SHEET		1		OF		1	
MESA TOPS AT RIDGEGATE		ENTRANCE ROAD ALT A — W/O WALLS					
JOB NO.		15950.12

MESA TOPS AT RIDGEGATE
ENTRANCE ROAD ALT B
WI WALLS

PRELIMINARY ROAD REDESIGN
ALTERNATIVE 1
MESA TOPS – CABELA DRIVE
1595018
10/28/2024
SHEET 1 OF 2

Earthwork Volume
Base Surface 1595012eg-google
Comparison Surface Alternative F
Cut volume (unadjusted) 37,011 Cu. Yd.
Fill volume (unadjusted) 12,491 Cu. Yd.
Net volume (unadjusted) 24,520 Cu. Yd.<Cut>

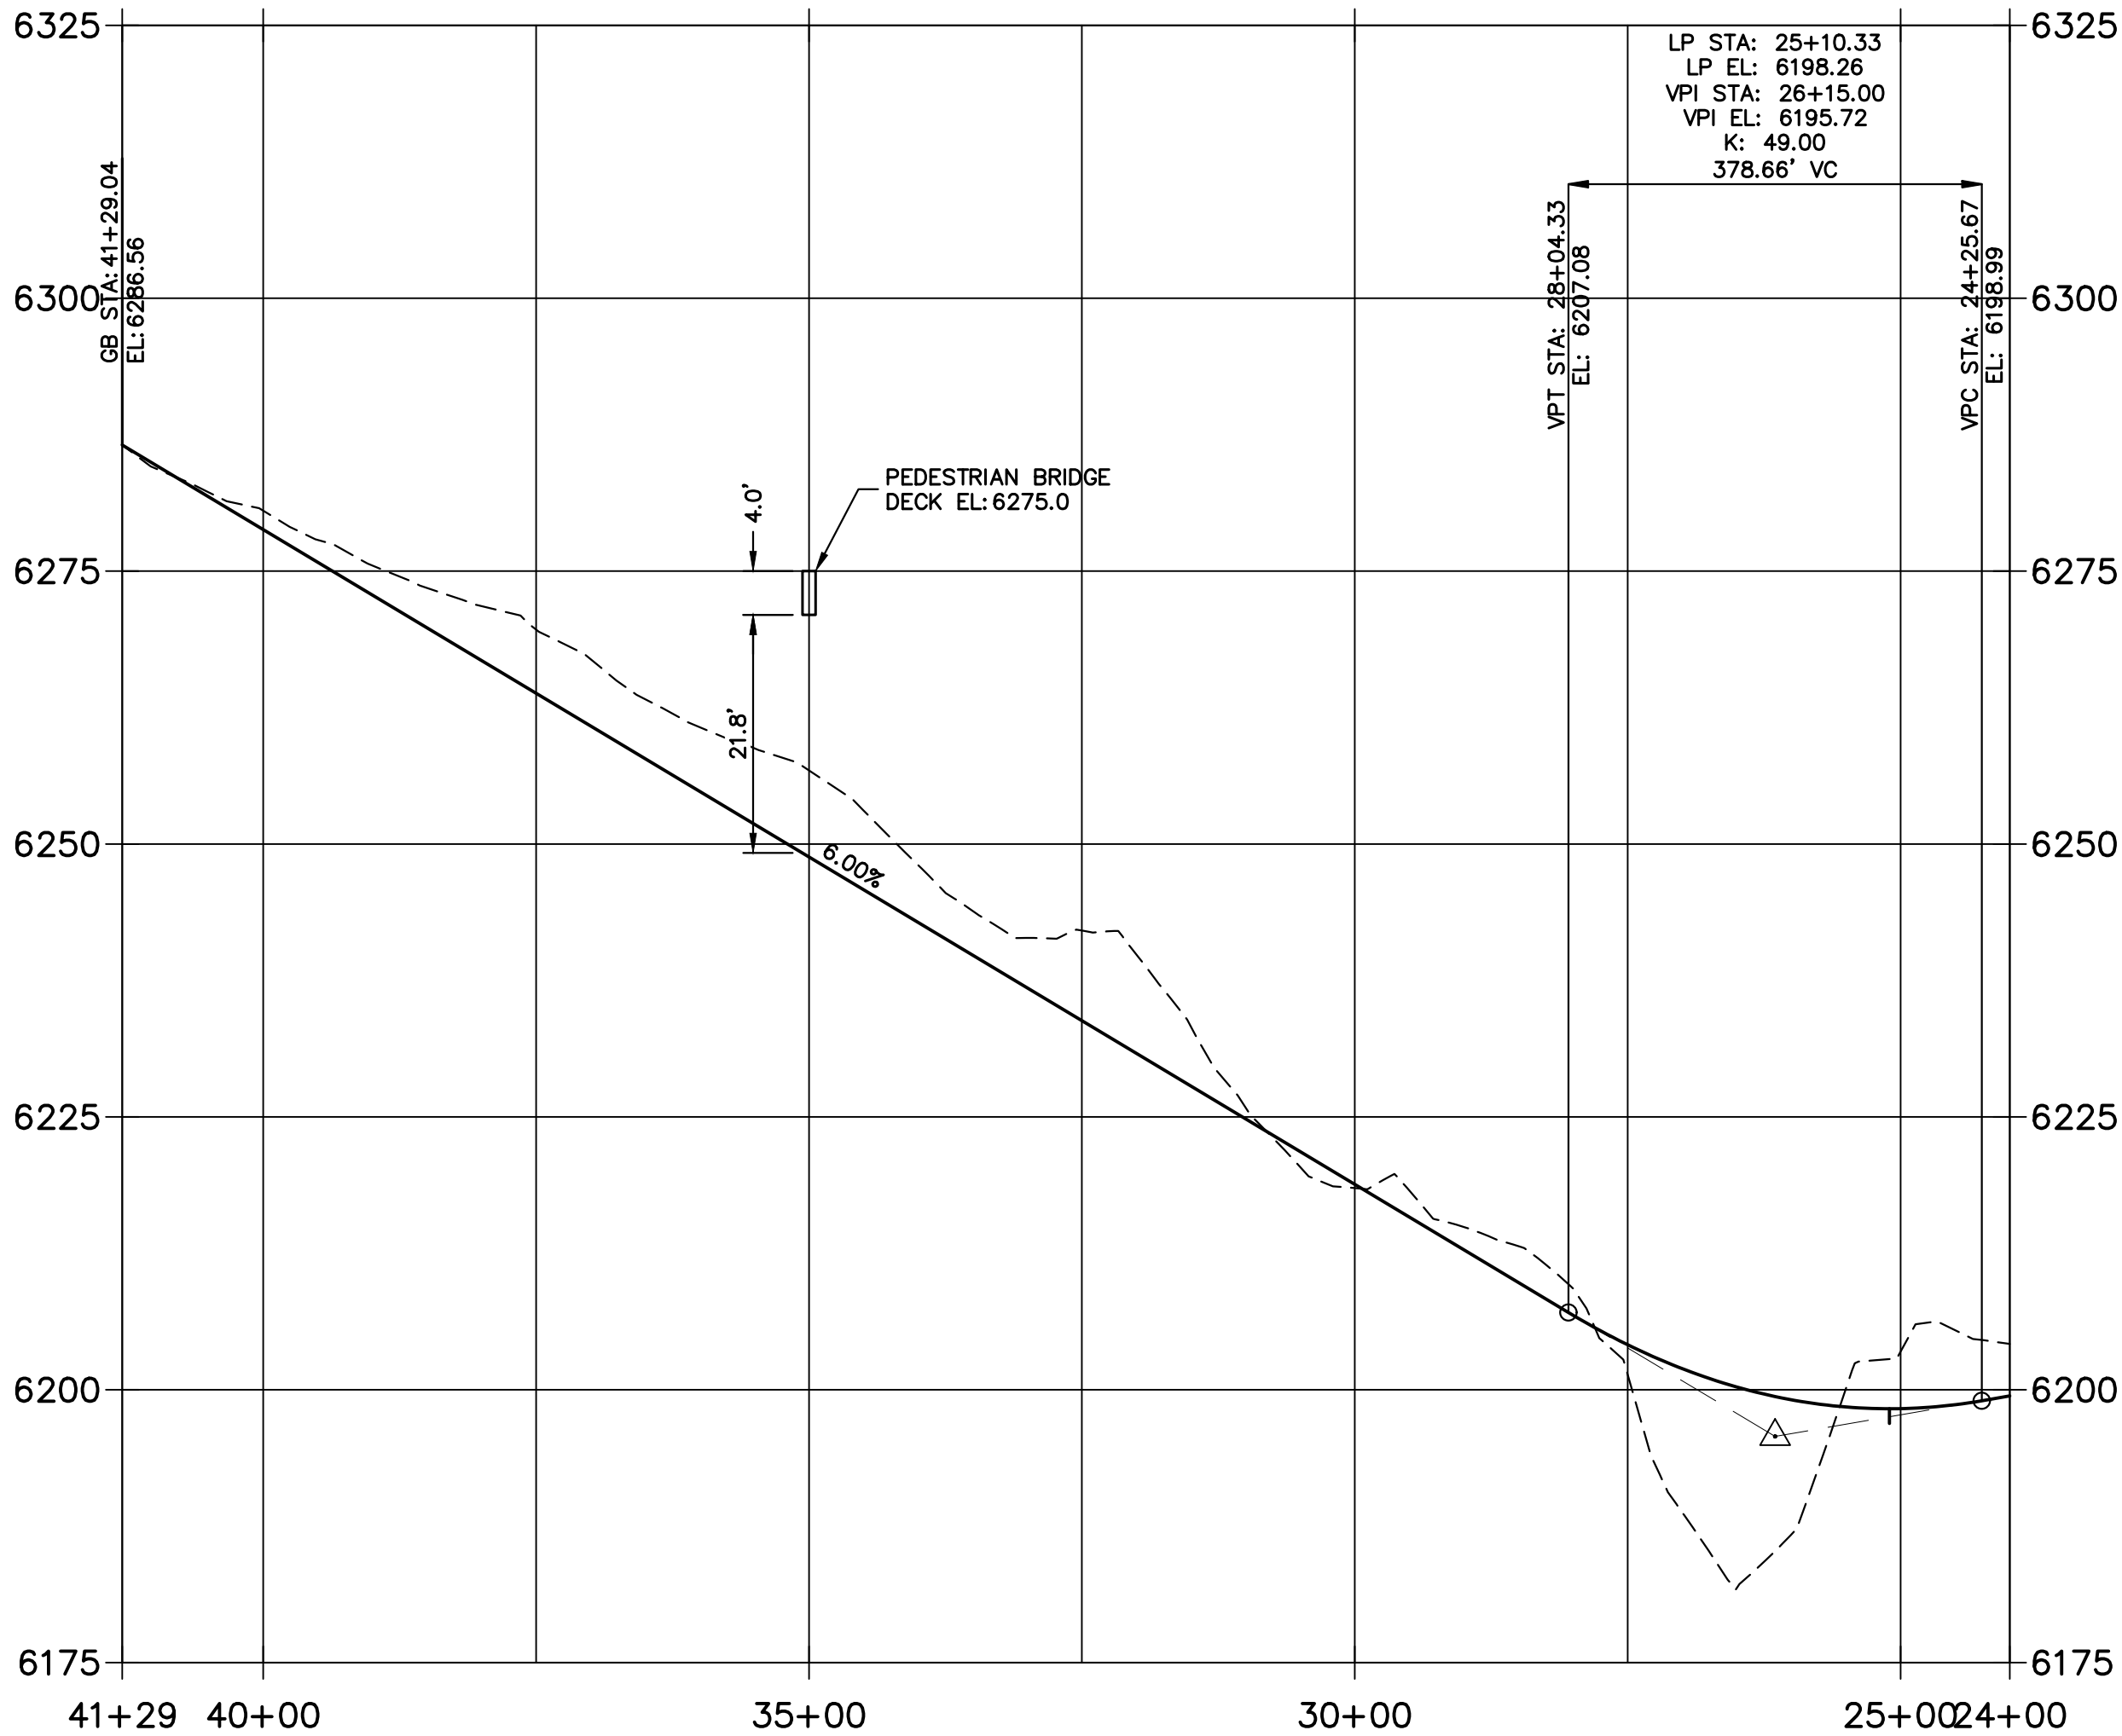
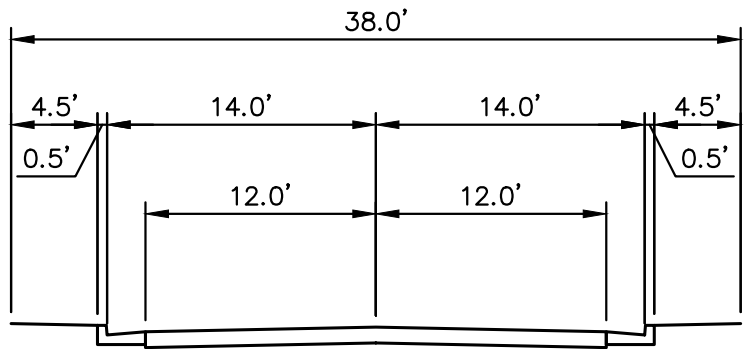
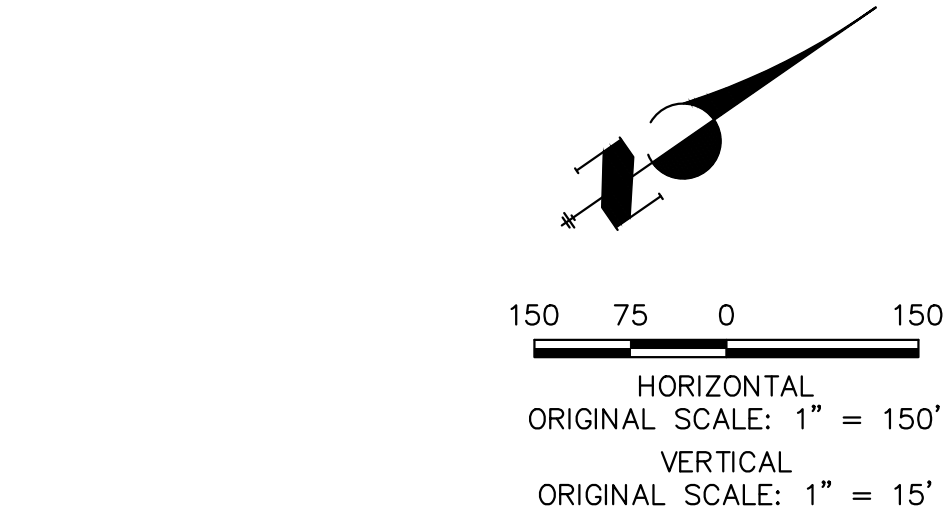
Option not selected -

- Typical section does not include sidewalk.
- Current alignment generally follows with horizontal and vertical curve criteria meeting collector standards and retaining walls revised.

SHEET ----- OF 1		MESA TOPS AT RIDGEGATE		H-SCALE 1"=150'		No.		REVISION		BY		DATE	
JOB NO. 15950.12		ENTRANCE ROAD ALT G		V-SCALE 1"=15'									
				DATE 10/31/23									
				DESIGNED BY JP									
				DRAWN BY JP

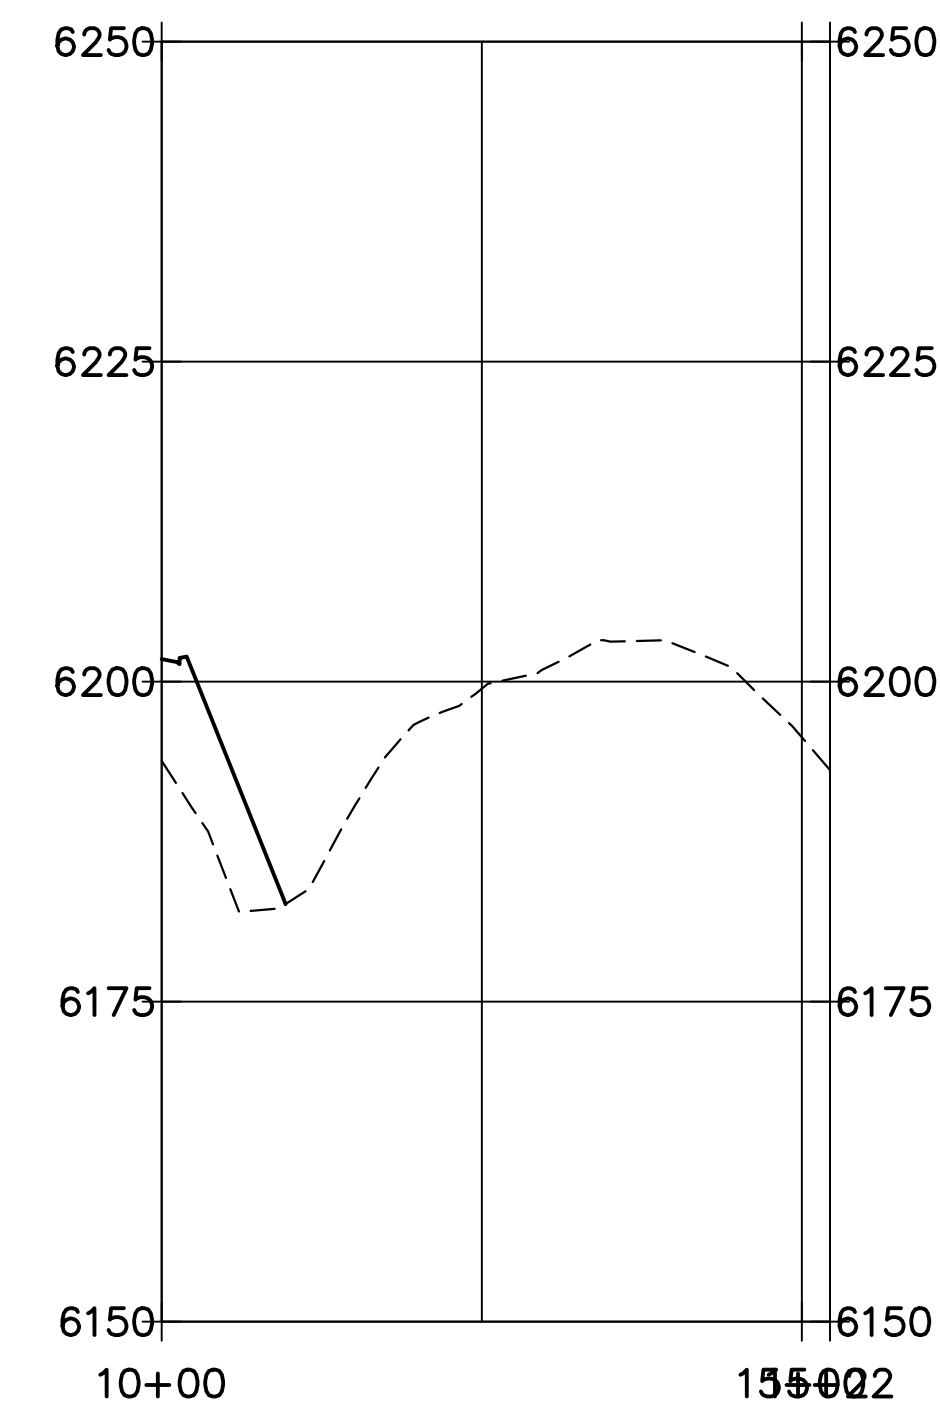
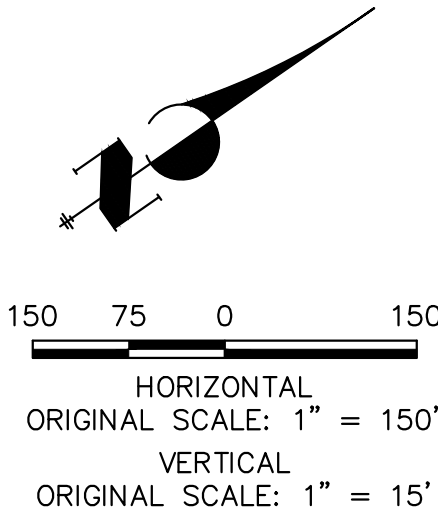
Option not selected -

- Typical section does not include sidewalk.
- Current alignment generally follows with horizontal and vertical curve criteria meeting collector standards and retaining walls revised.
